## BCA Report

20-22 Atchison St  
St Leonards, NSW

Report No: 25056-102-R01 BCA Report  
Revision: 02  
Date: 22 September 2025

Ref: 25056-106-R01 BCA Report Rev02 Marked Plans  
 Reviewed by: Dishana Liang  
 Date: 22/09/2025

Drawing Title: **BASEMENT 4**

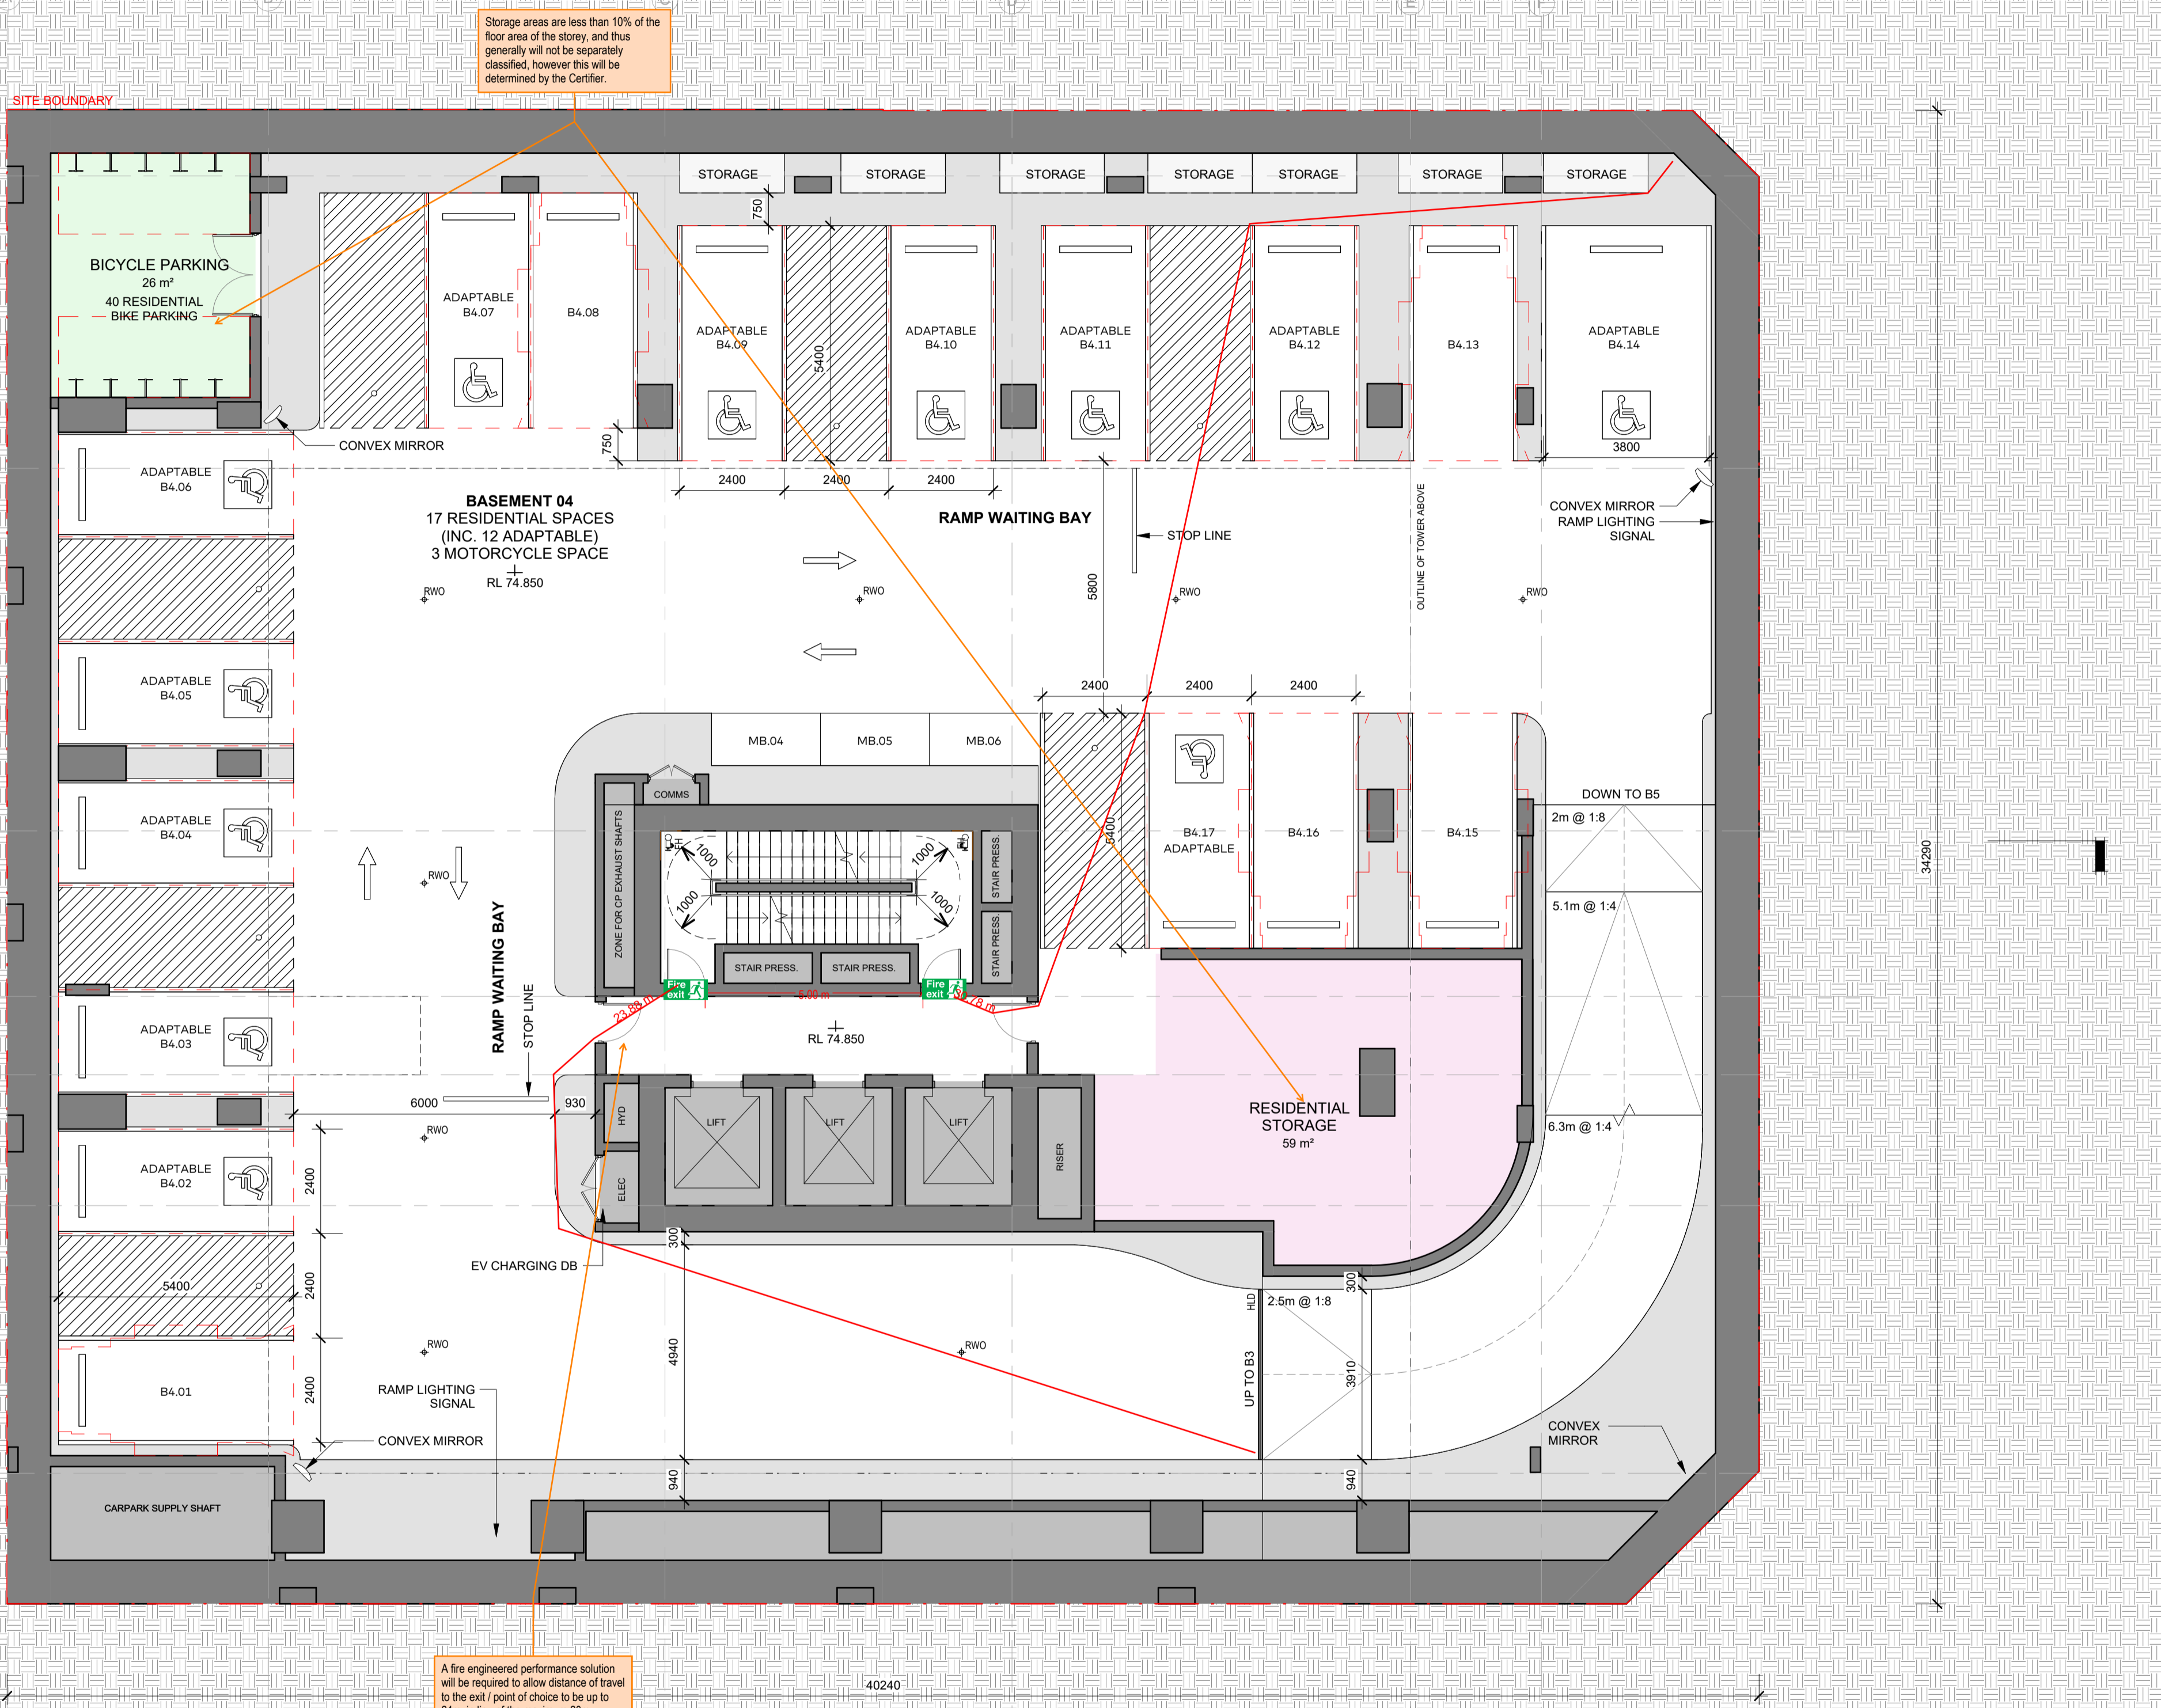
Storage areas are less than 10% of the floor area of the storey, and thus generally will not be separately classified, however this will be determined by the Certifier.

A fire engineered performance solution will be required to allow distance of travel to the exit / point of choice to be up to 24m, in lieu of the maximum 20m.

**Drawing Title**  
BASEMENT EGRESS

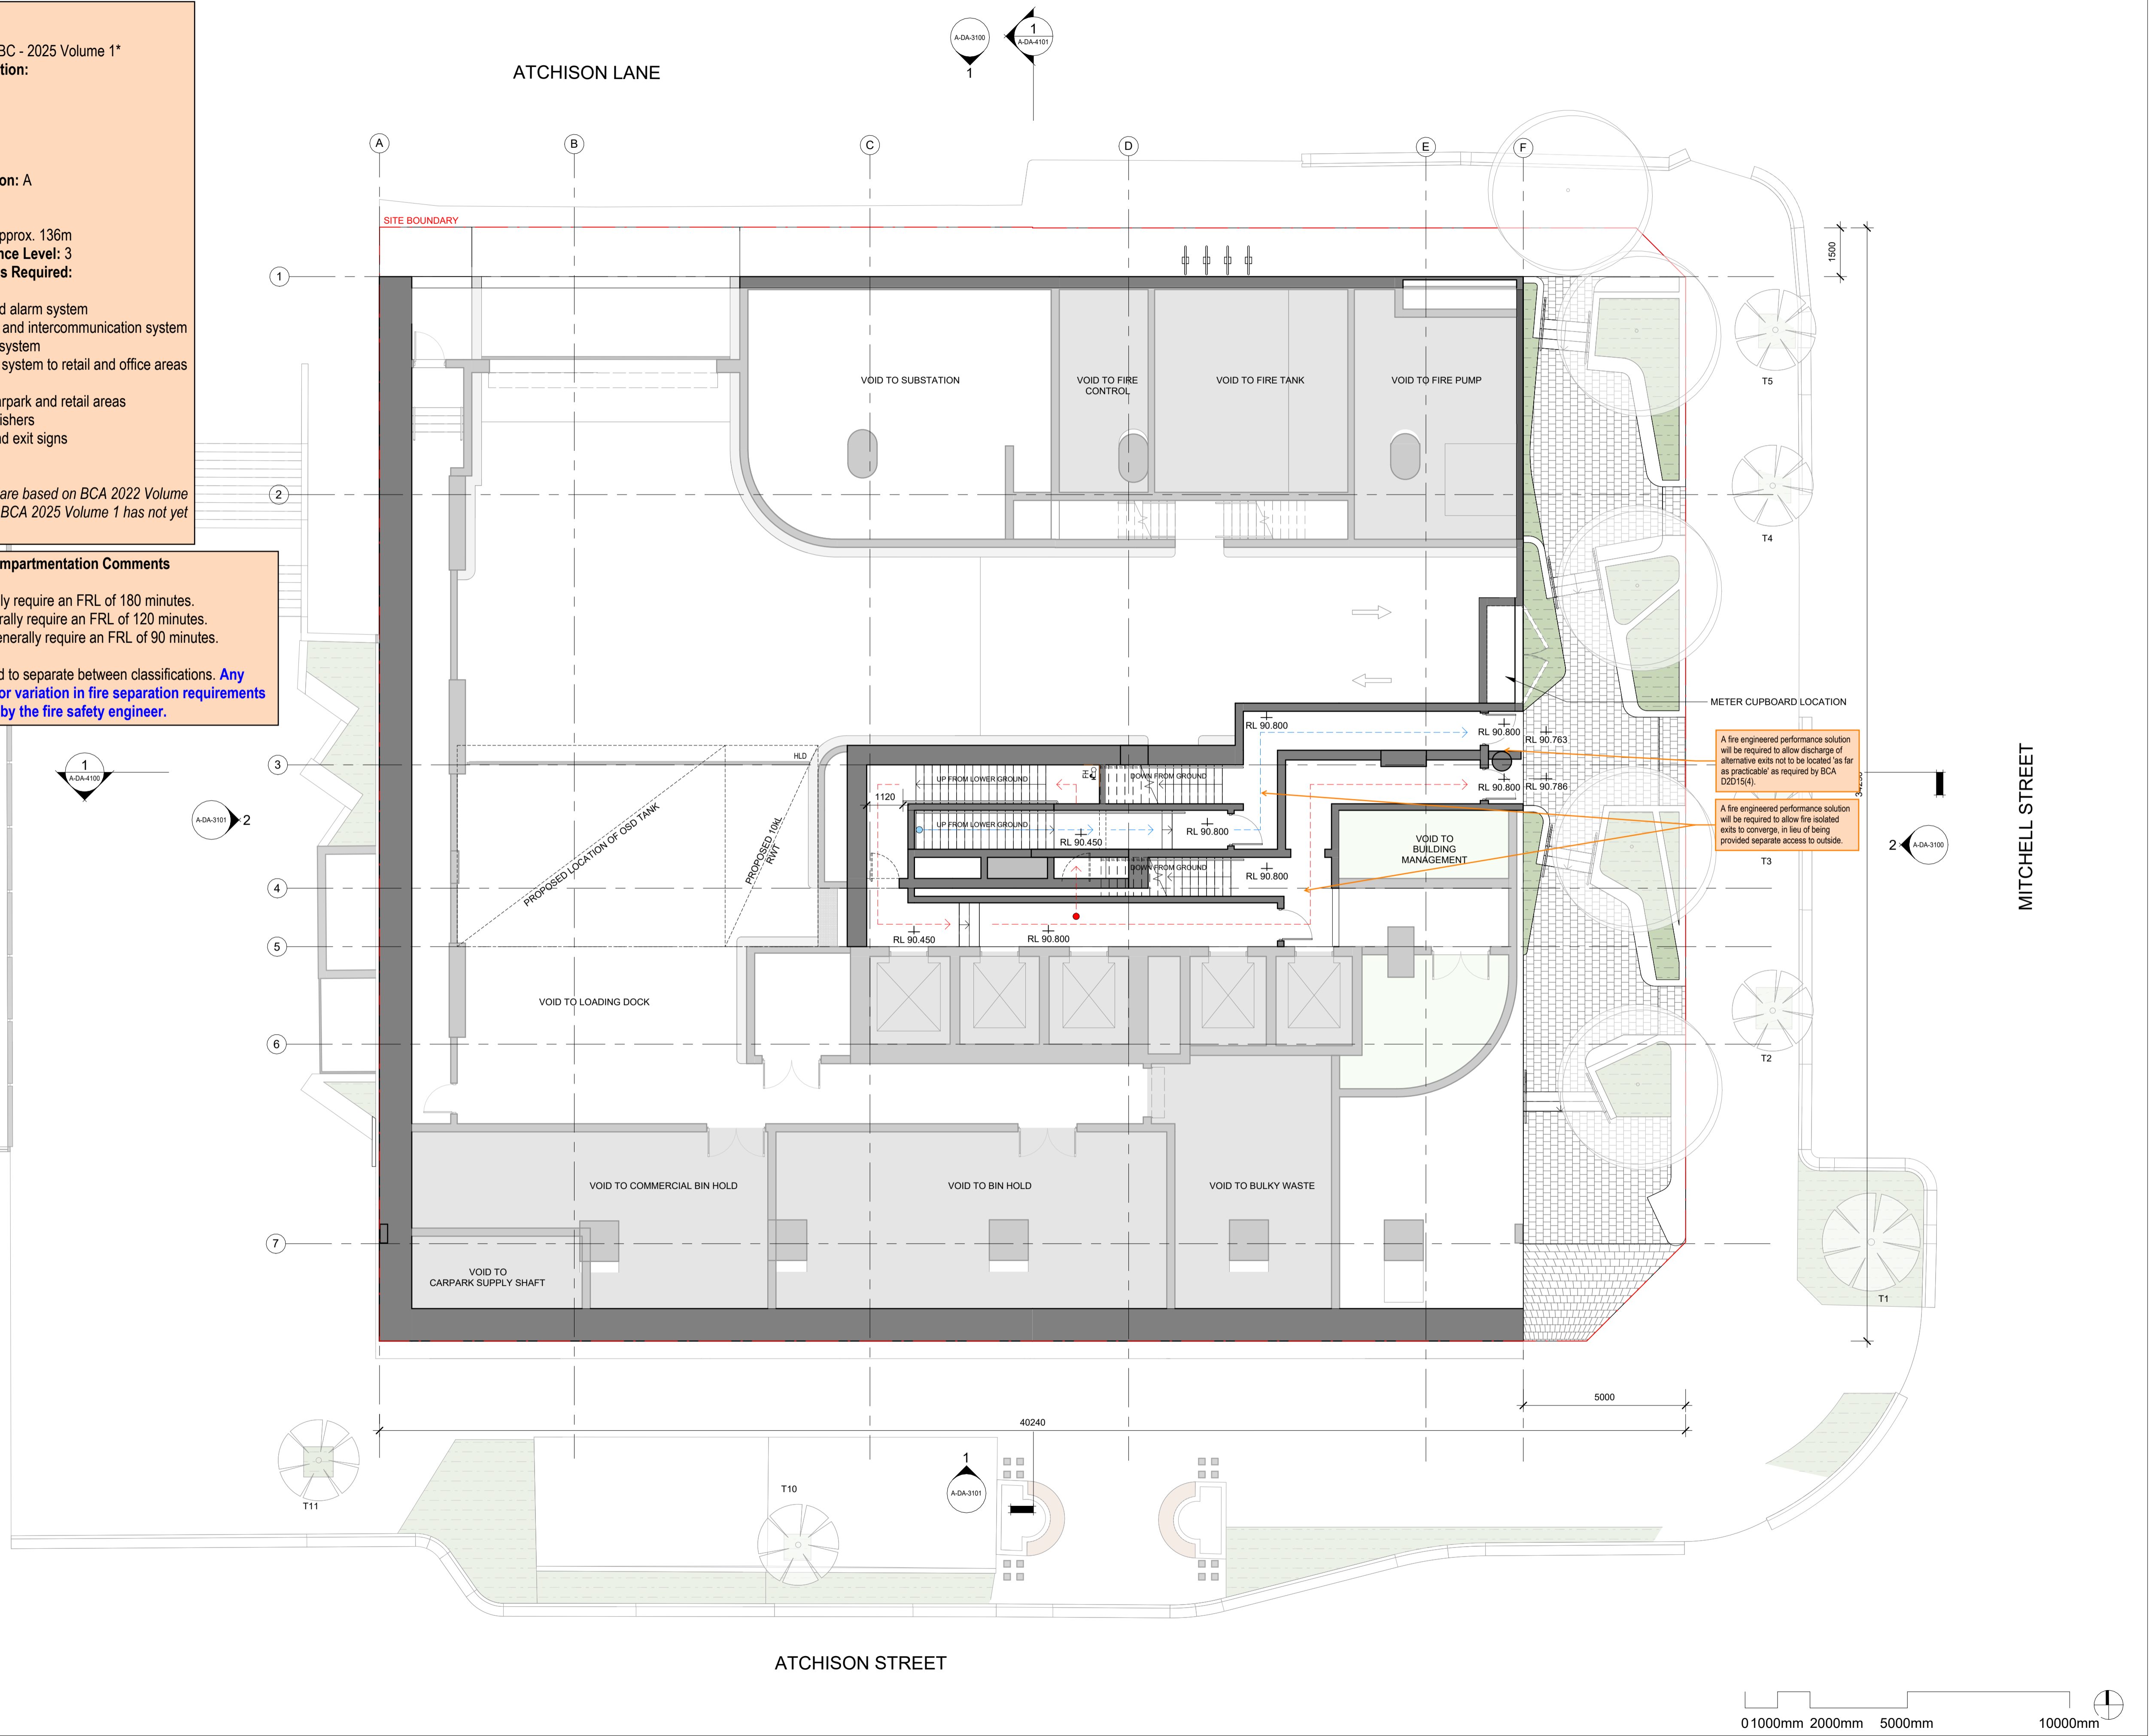
A fire wall is required to separate between classifications. **Any reductions in FRL or variation in fire separation requirements will require review by the fire safety engineer.**

Drawing Title: **GROUND FLOOR**

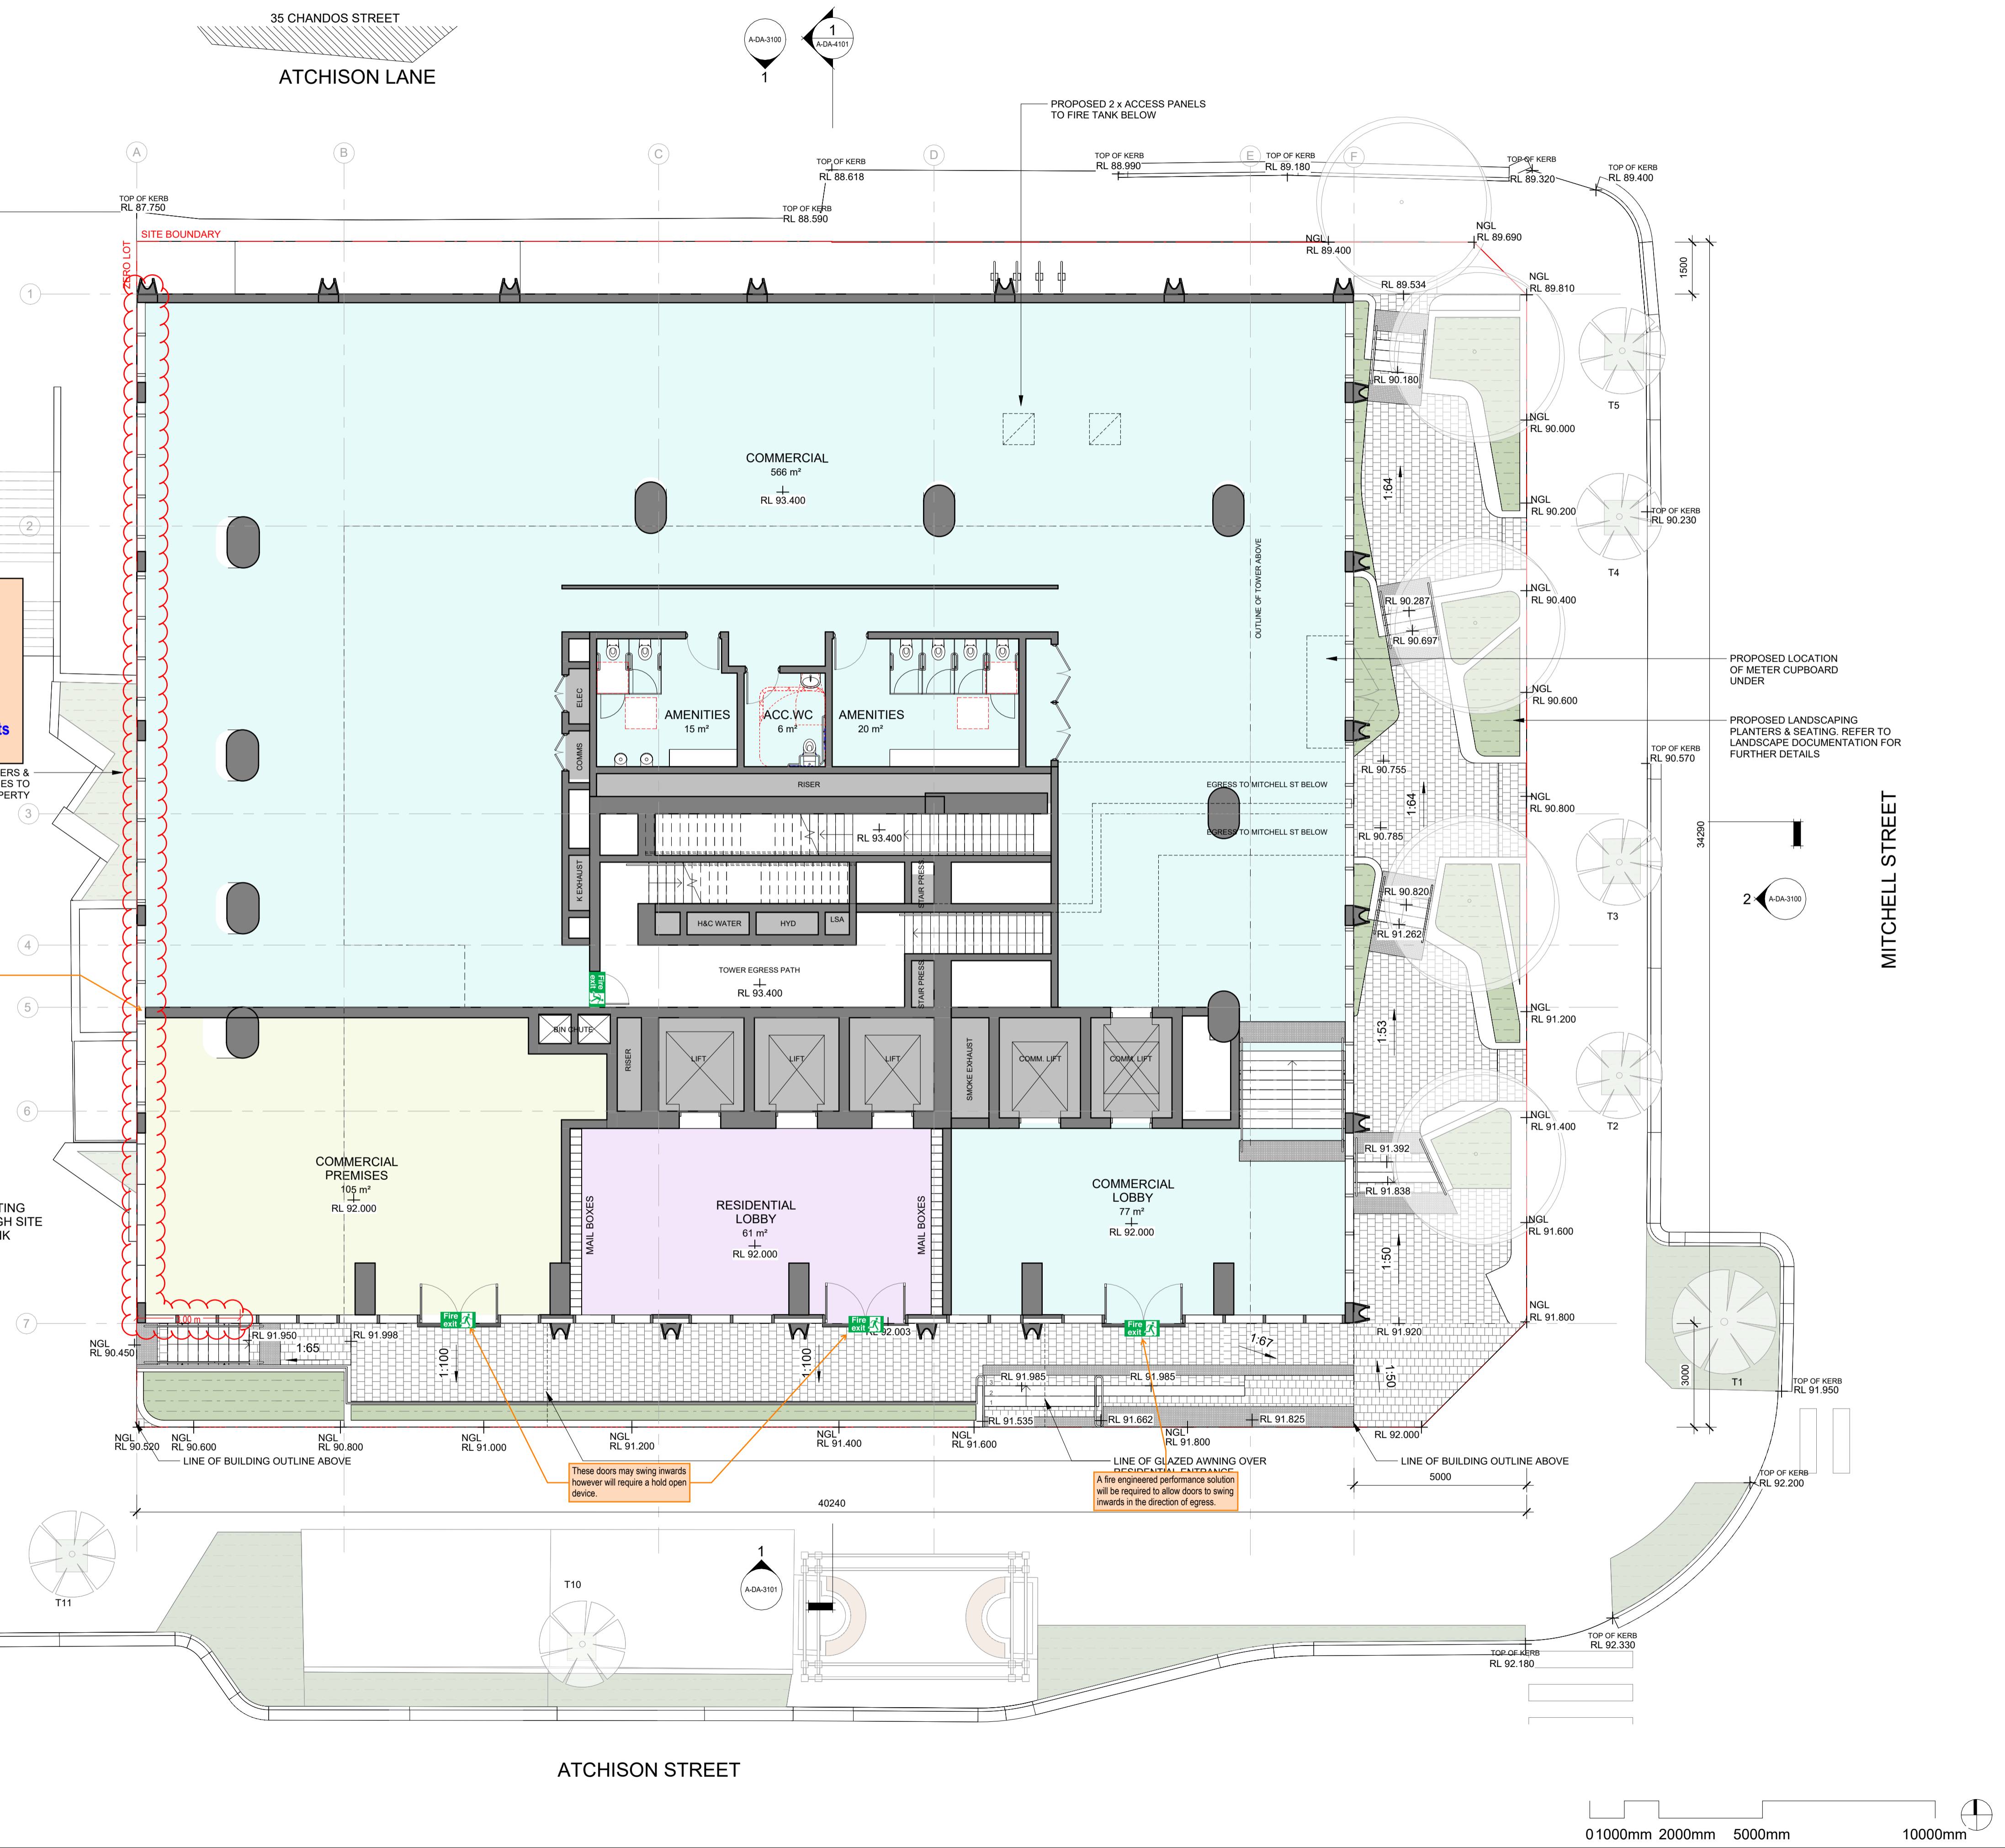
A fire wall is required to separate between classifications. Any reductions in FRL or variation in fire separation requirements will require review by the fire safety engineer.
